To: Adam Grady, Hanover Design
From: Pat O’Mahony, Associate Planner; 910-341-0189
CC: File;
Date: 6/22/2021
Re: Wilmington Health TRC Rev. 2

Project Name: **WILMINGTON HEALTH MEDICAL OFFICE**

Project Name: (WILMINGTON HEALTH) 1305 GLEN MEADE RD

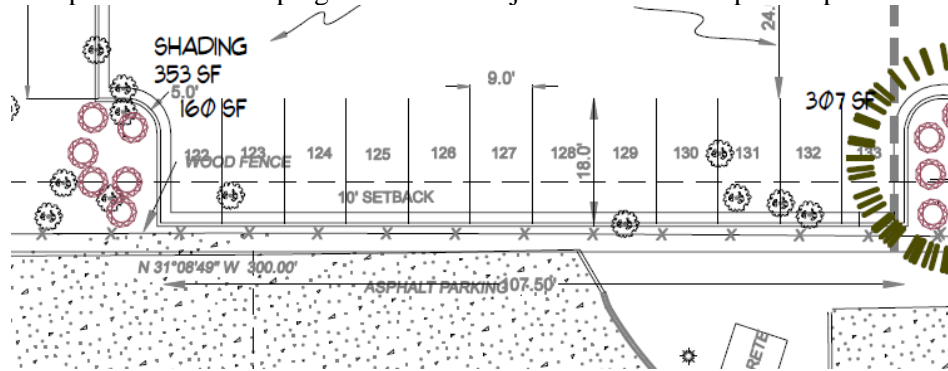
- Plantings are shown on the existing pine (highlighted in yellow).

- The interior area of a parking facility shall be shaded by canopy trees either planted or retained to provide **thirty-five (35) percent** or greater canopy coverage at maturity per Sec. 18-481(i)
- If solid artificial fencing is used two (2) rows of planted materials consisting of a combination of trees and shrubs shall be provided at a minimum height of three (3) feet at

initial planting and give at least fifty (50) percent visual opacity of the fence at planting. (Sec. 18-503.c.2)
